SERVICE LETTER

FOR REPAIR OF MODEL 301

COCKPIT DISPLAY BOX DOOR POSITION LED

Document No.: Date: Used On: SL2009-007 September 8, 2009 Simplex Model 301

FIGURE 1-4

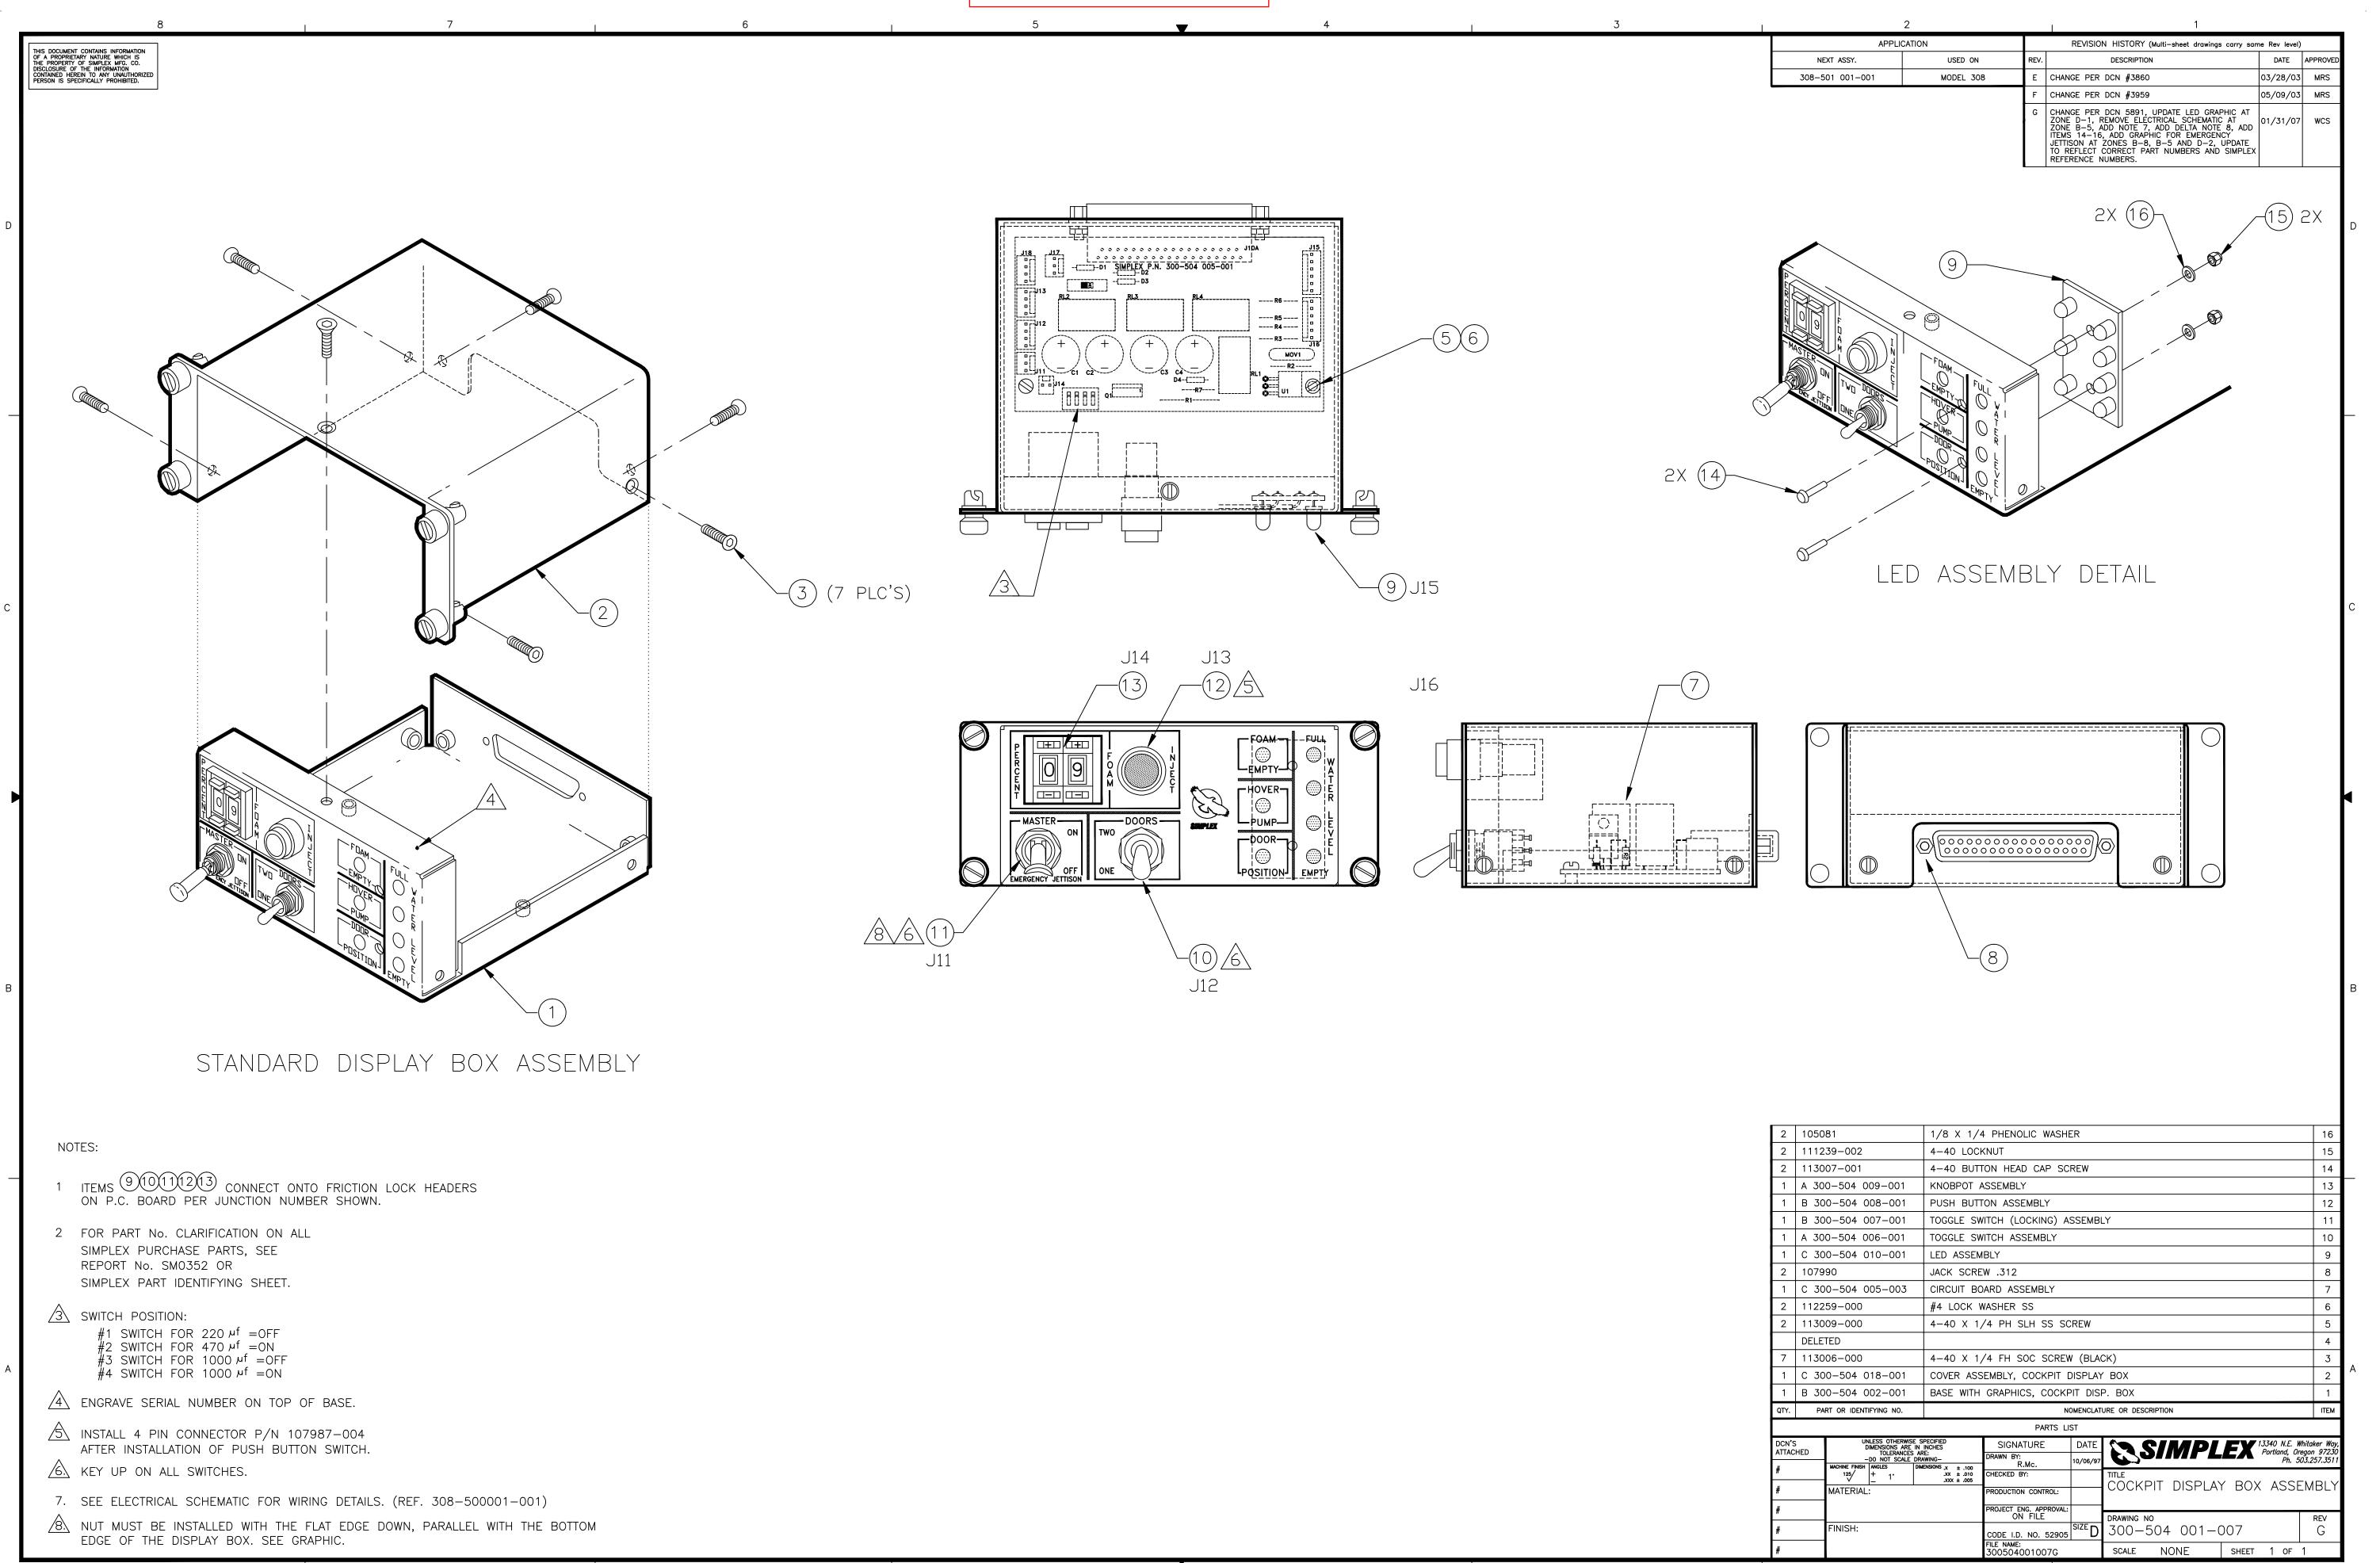
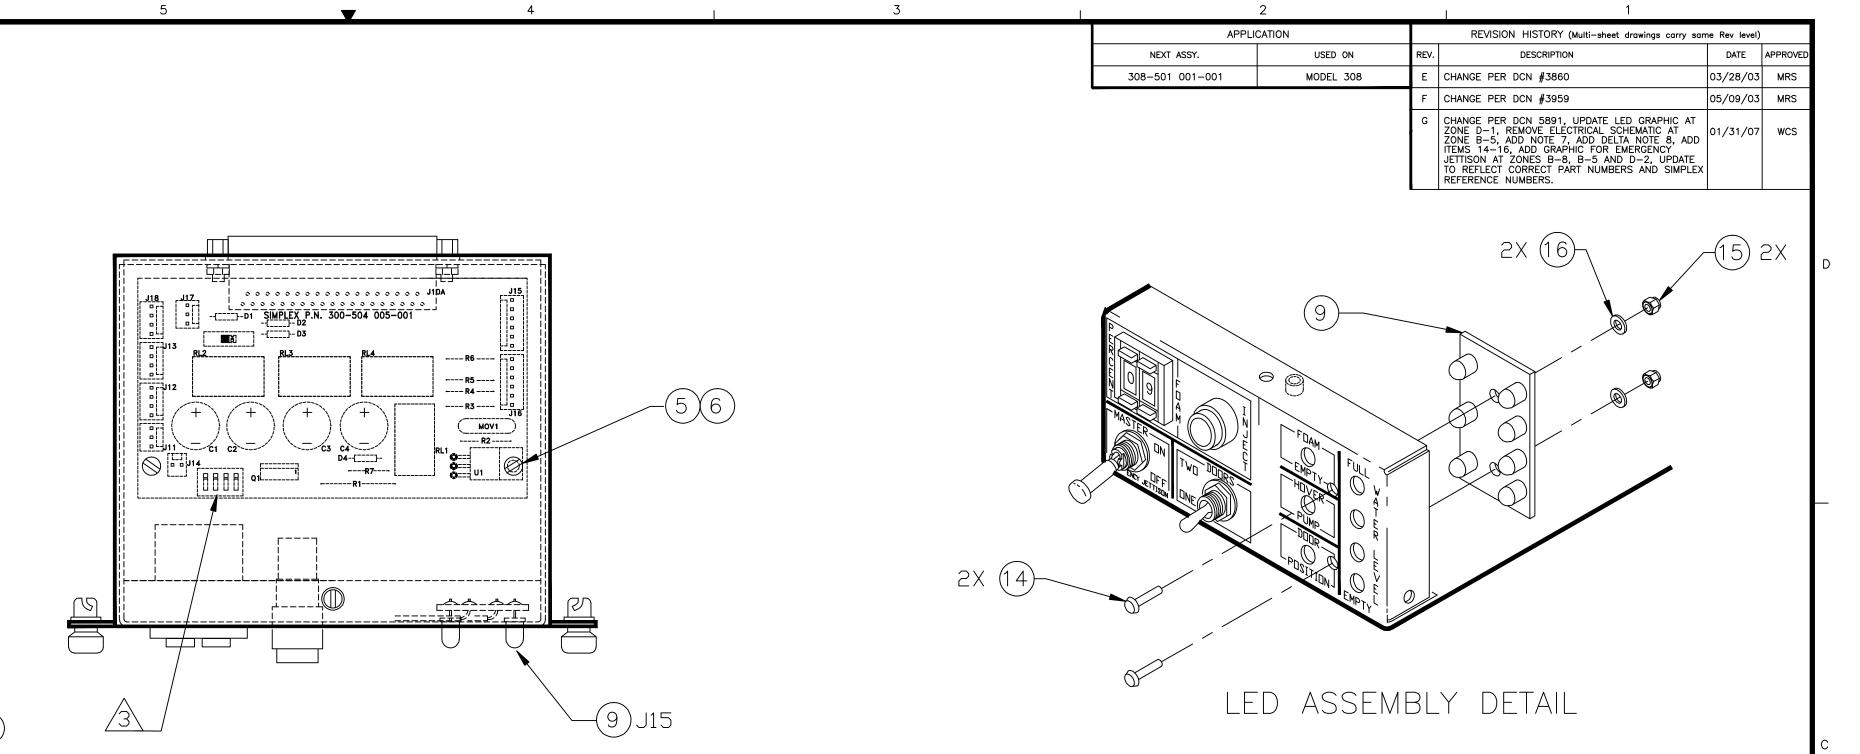
Step	Description				
1	Remove the seven (7) screws (item 3) from the CDB outer shell as shown on drawing 300- 504001-007 zone C6, C7, D7 and D8 Remove outer CDB shell to access internal components. Retain hardware for re-installation.				
2	Remove the two (2) screw assemblies items 14, 15 and 16 shown on drawing 300-504001- 007. Retain hardware for re-installation.Reference Figure 1-1.				
3	Disconnect the two (2) electrical connectors at J15 and J16 in the CDB. Reference Figure 1- 2.				
4	Remove LED panel from CDB.				
5	Install new P/N P/N 300-504005-003 LED ASSEMBLY using hardware removed from Step 2.				
6	Connect door position LED harness connector to J16 in the CDB. Reference Figure 1-3.				
7	Connect the inboard LED harness to connector J15 in the CDB. Reference Figure 1-4.				
8	Re-install CDB outer shell using hardware removed from Step 1. Reference drawing 300- 504001-007.				
	This completes the removal and re-installation of the CDB LED panel.
